**Before the Hearing Panel appointed by Canterbury
Regional Council and Waimakariri District Council**

IN THE MATTER OF Applications CRC204106,
CRC204107, CRC204143,
CRC211629 and RC205104 to
establish, operate, maintain
and rehabilitate an aggregate
quarry by Taggart Earthmoving
Limited

SUMMARY STATEMENT

**SECTION 42A REPORTING OFFICER
CANTERBURY REGIONAL COUNCIL AND WAIMAKARIRI
DISTRICT COUNCIL
PLANNING – ADELE DAWSON**

Figure 1: Land owned by Environment Canterbury shown in cross hatch

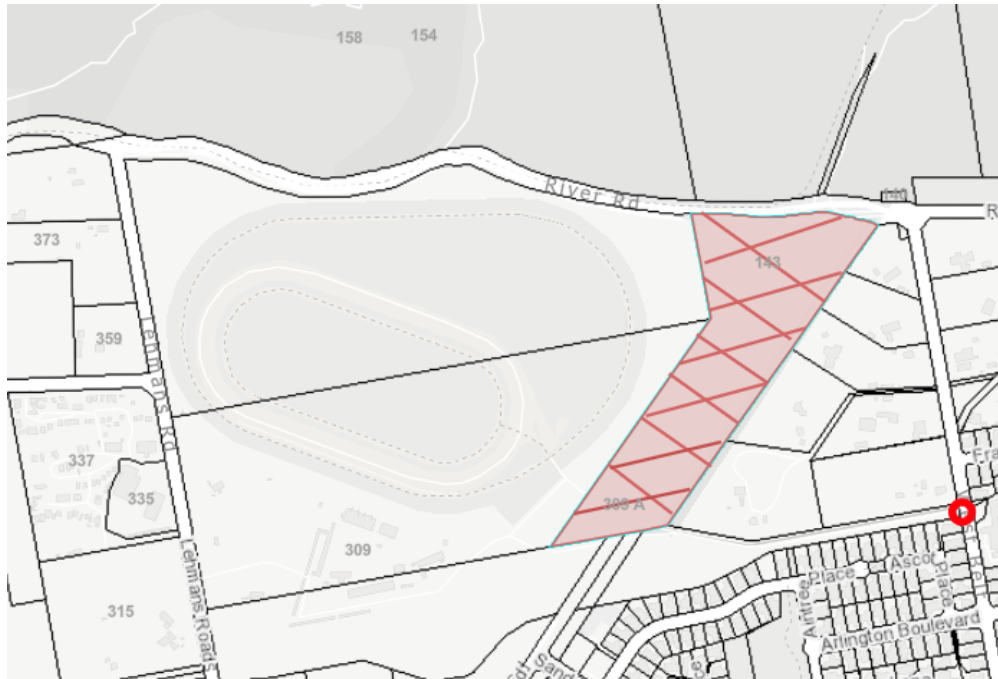
28. Commissioner Rogers has sought information on the intended use of land owned by Environment Canterbury located to the east of the racecourse.
29. Environment Canterbury own land parcel Section 1 SO 533423 which is 7.3ha and identified in Figure 1 below.

30. Advice from Colin Brookland, Team Leader Reserves at Environment Canterbury confirms that the land has been under a grazing licence to the Rangiora Racecourse Grounds Committee for many years. The current licence is for a 5-year term starting on January 1st 2021. Waimakariri District Council have approached Environment Canterbury regarding their plans to construct a road on this land but it is understood this is provisional and dependant on agreement with Transpower who have power pylons along the length of the site. Indicative drawings of the road show that only a portion of this land would be required for the road reserve.

31. Mr Brookland was asked if it would be possible to install monitoring bores on this land. His response was that it was likely there would be sufficient space to do so, even if the road was to proceed.

Figure 2: Current residential zoning east of the racecourse

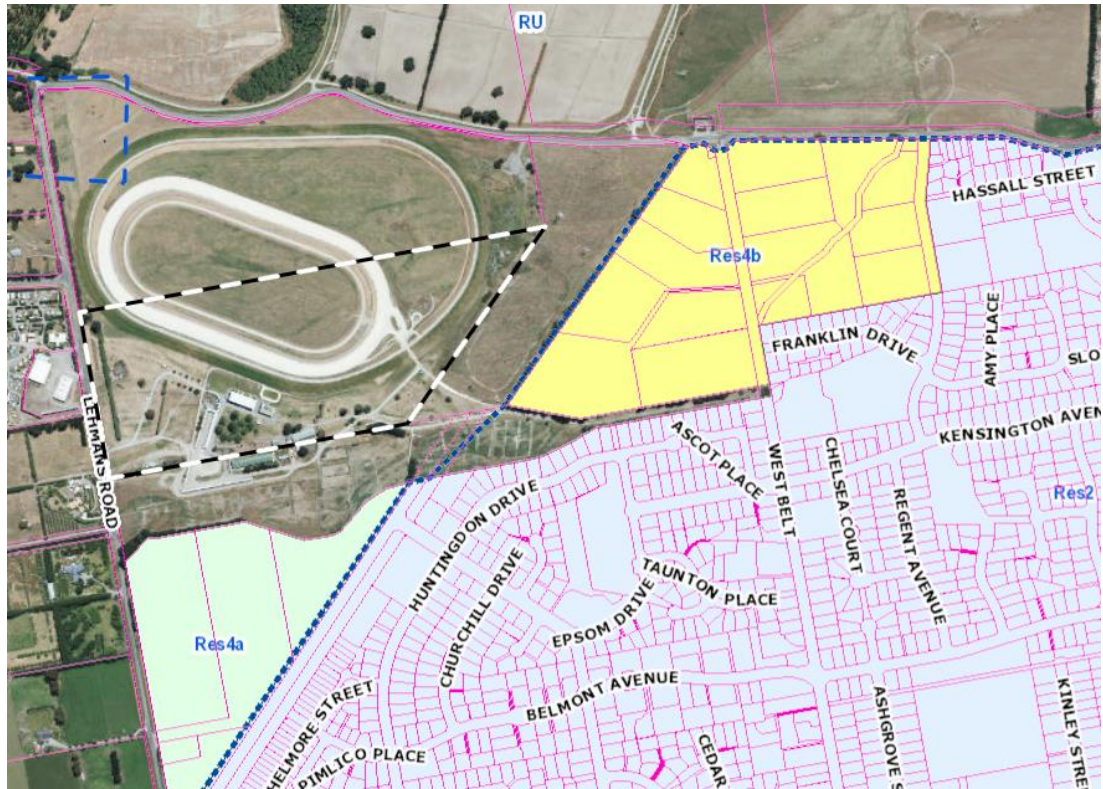
32. Commissioner Rogers has also sought information from WDC regarding the land use zoning in the Proposed District Plan for the land between the racecourse and West Belt.

33. At this stage WDC cannot comment on the likely rezoning of this land as the Proposed District Plan has not been notified, that is, Council is yet to sign off on the final proposal for public notification. As this information is not in the public domain and is subject to a submission period, hearing and decision process it is difficult to comment specifically on the rezoning of the land in question.

34. However, WDC is currently working through zoning options and notes that the infrastructure boundary set out in the CRPS incorporates this area.⁴ In terms of land within the infrastructure boundary, zoning description and density changes are within the scope of the District Plan review. Further, the land currently zoned Res 4B to the east of the quarry site and the small area of land between the current Residential 2 and Res 4B zoning located at 309 West Belt, Rangiora (see Figure 2) are under consideration as being more appropriate to be rezoned residential. The Res 4B zoning is likely to be subject to an Outline Development Plan and the parcel at 309 West Belt is likely to be rezoned to residential, akin to the current Residential 2 zoning.
